### **Groundwater Transfer Review Summary Form**

Transfer/PA # T- <u>14269</u>
GW Reviewer <u>Grayson Fish</u> Date Review Completed: <u>11/13/2023</u>
Summary of Same Source Review:
☐ The proposed change in point of appropriation is not within the same aquifer as per OAR 690-380-2110(2).
Summary of Injury Review:
☐ The proposed transfer will result in another, existing water right not receiving previously available water to which it is legally entitled or result in significant interference with a surface water source as pe 690-380-0100(3).
Summary of GW-SW Transfer Similarity Review:
$\Box$ The proposed SW-GW transfer doesn't meet the definition of "similarly" as per OAR 690-380-2130.
This is only a summary. Documentation is attached and should be read thoroughly to understand the

Application: T-14269

#### **Transfer Review Map**

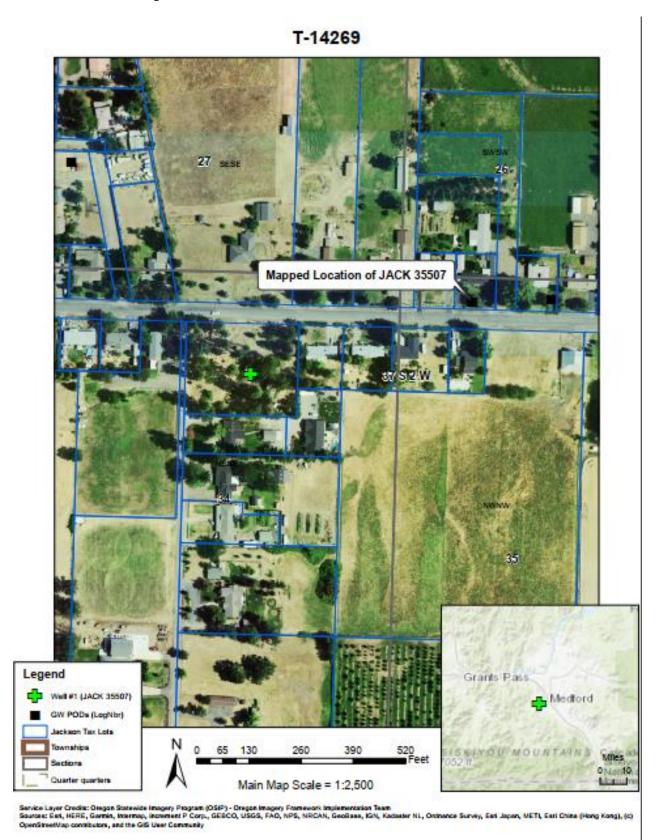
☐ Permit Amendment **⊠** GR Modification ☐ Other Applicant Name: Erick Clements  $\square$  SW $\rightarrow$ GW  $\square$  RA  $\boxtimes$  OTHER Date of Review: 11/13/2023 Date Reviewed by GW Mgr. and Returned to WRSD: The information provided in the application is insufficient to evaluate whether the proposed The water well reports provided with the application do not correspond to the water rights The application does not include water well reports or a description of the well construction details sufficient to establish the ground water body developed or proposed to be developed. 1. Basic description of the changes proposed in this transfer: The applicant proposes to correct the location of the POA (Well #1, JACK 35507) and POU listed on Groundwater Claim GR 2512 from T37S R2W S35 NW NW to T37S R2W S34 NE NE. The physical location of the POA and POU are not changing. Note: the applicant lists the POU on Table 2 of the application as being in Township "39 S", this is likely an error and should read Township 2. Will the proposed POA develop the same aquifer (source) as the existing authorized POA? Comments: The physical location of the POA is not changing, therefore 3. a) Is there more than one source developed under the right (e.g., basalt and alluvium)? b) If yes, estimate the portion of the right supplied by each of the sources and describe any limitations that will need to be placed on the proposed change (rate, duty, etc.): N/A a) Will this proposed change, at its maximum allowed rate of use, likely result in an increase in interference with another ground water right? No Comments: The physical location of the POA is not changing, so no increase in interference is anticipated with another groundwater right.
